City of Sedona Wastewater Department

The City of Sedona, Arizona is issuing **Addendum # 4** to the plans and specifications as originally issued at the time of solicitation for bids for the **Wastewater Collection System Improvements – LS Improvements.** For any bid to be considered responsible and responsive, receipt of this addendum must be acknowledged.

Addendum # 4 issued by Roxanne Holland, PE, Wastewater Manager, City of Sedona

DESIGNED: [] DRAWN: [] CHECKED: [] SHEET NO: DT1

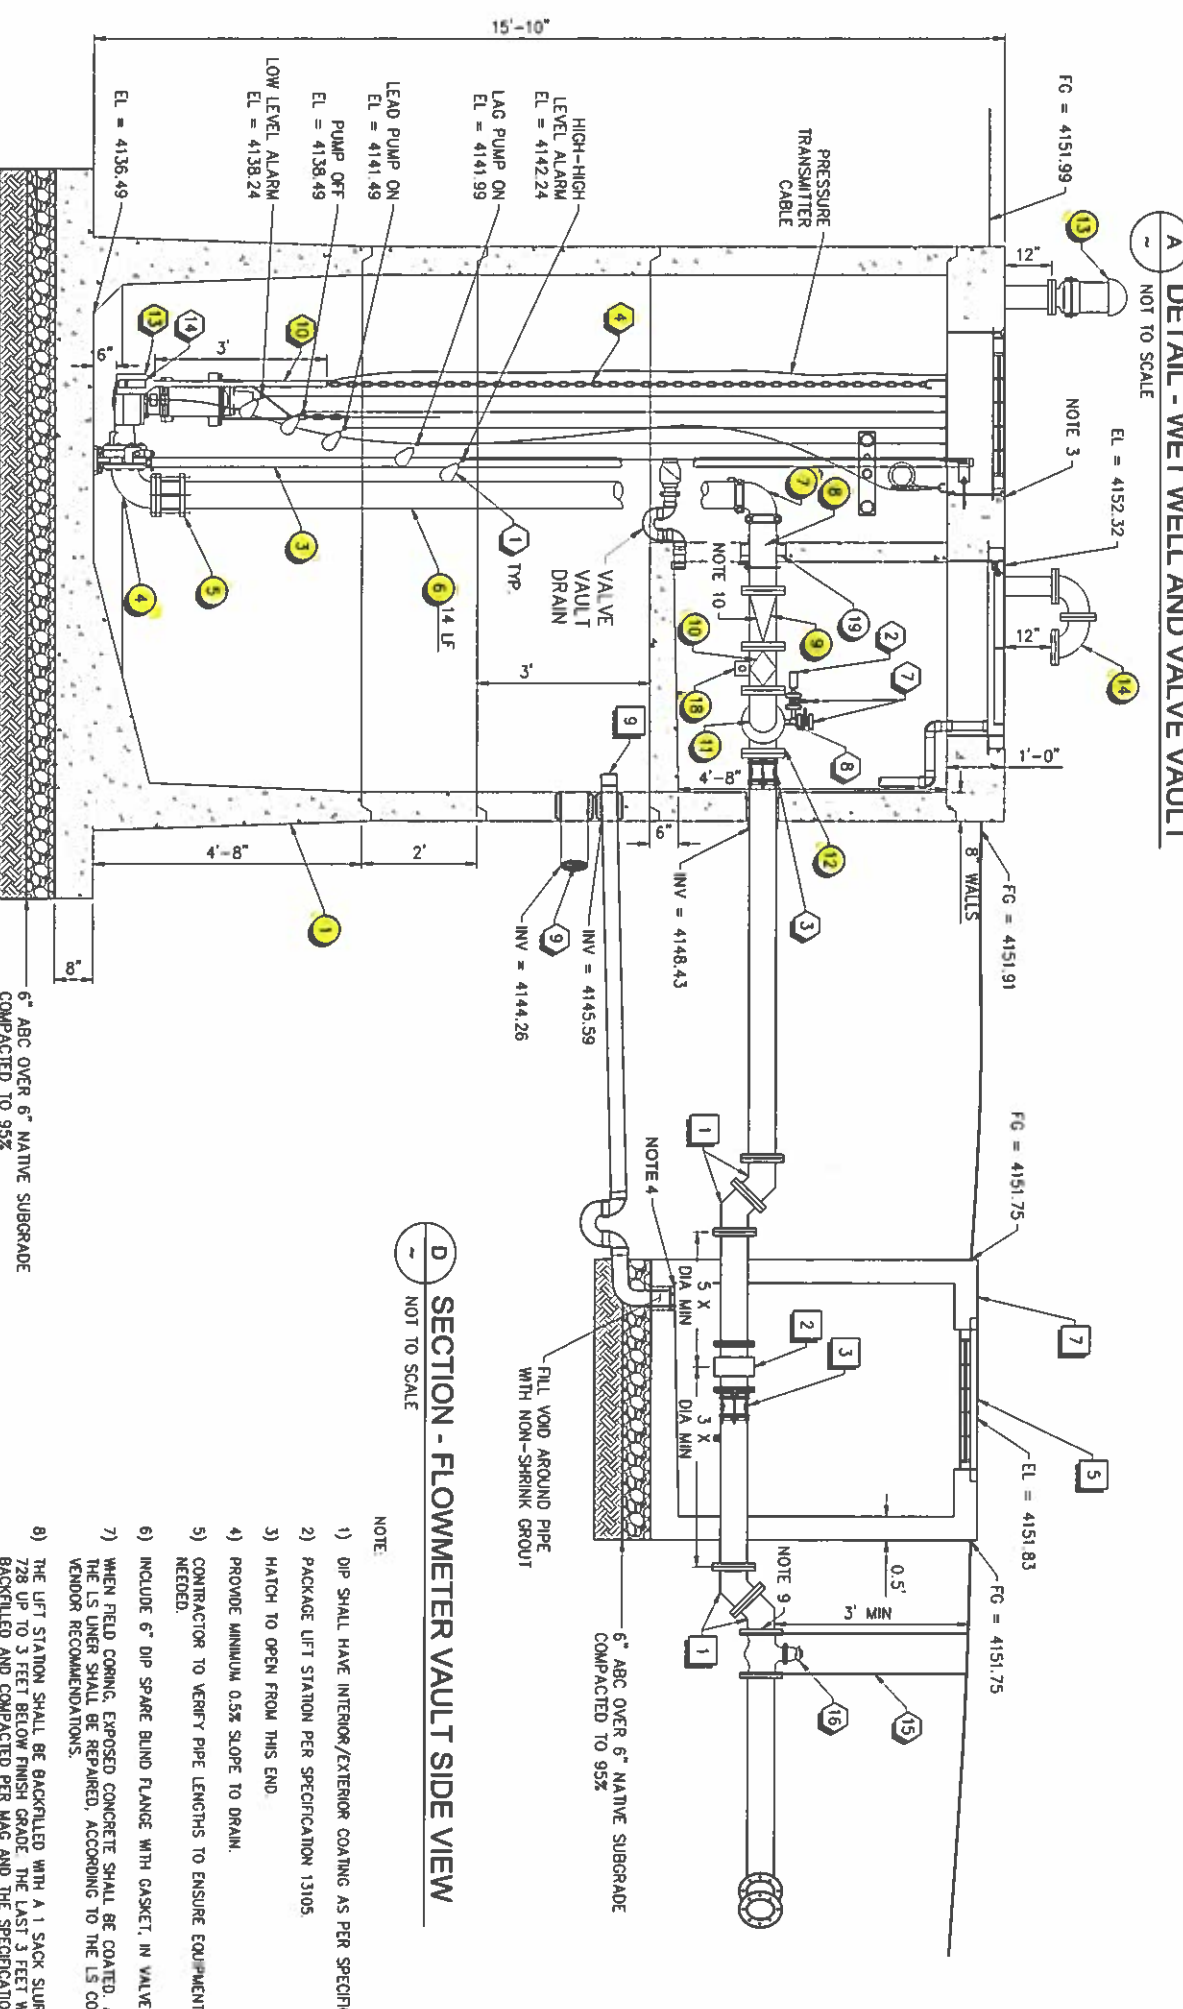
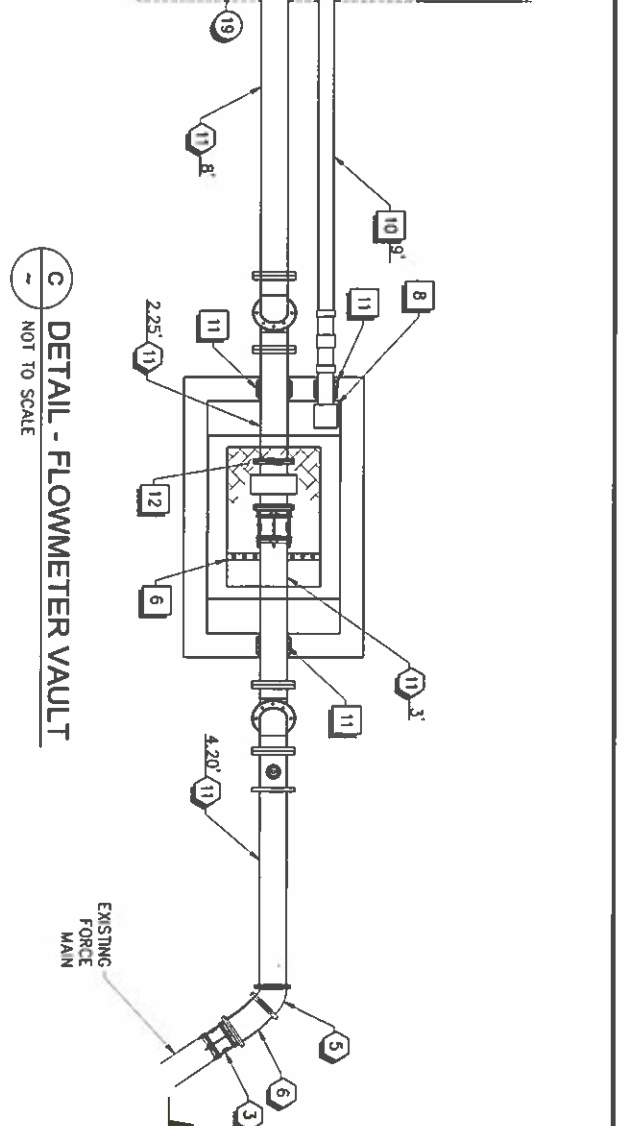
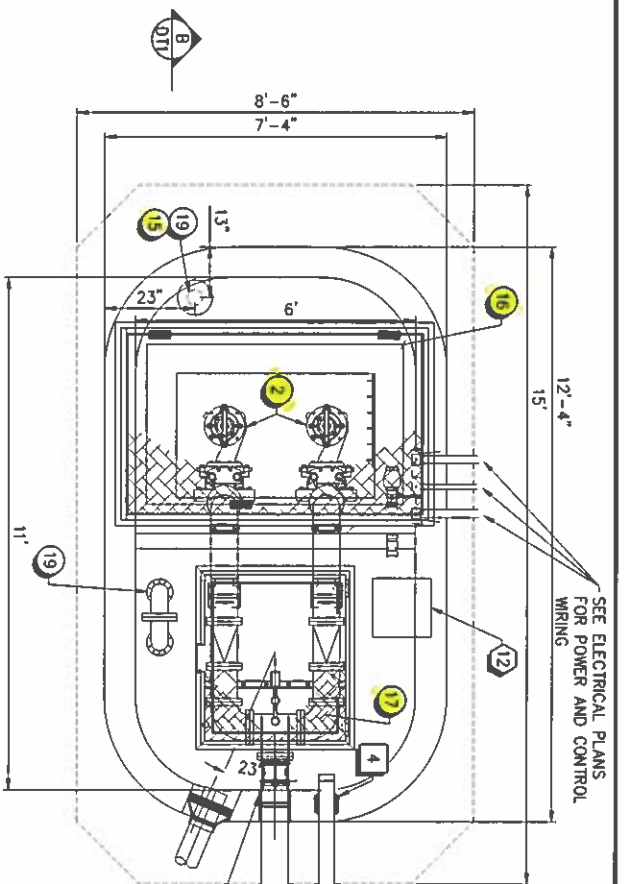
1. **The previous highlighted pages from addendum 2 shall be replaced with the following new sheet attachments:** Two (2) highlighted plan sheets, sheet 10 of 32 (DT1) for Chapel Lift Station; and sheet 10 of 36 (DT1) for Mystic Hills Lift Station, indicating materials (highlighted) as part of the City’s pre-negotiated pricing as shown in the Base Bid Schedule.
2. Base Bid Schedule (Rev. 2/28/19), pages 26 and 27.
3. Copies of the latest quotations submitted to the City for the Package Lift Station Systems, labeled as follows:
 - 3.1. QUOTATION #:20190225-007DPEL, DATE: FEBRUARY 28, 2019, JOB NAME: CHAPEL LIFT STATION from JCH and consisting of a total of 4 pages.
 - 3.2. QUOTATION #:20190225-007DPEL, DATE: FEBRUARY 28, 2019, JOB NAME: MYSTIC LIFT STATION from JCH and consisting of a total of 4 pages.
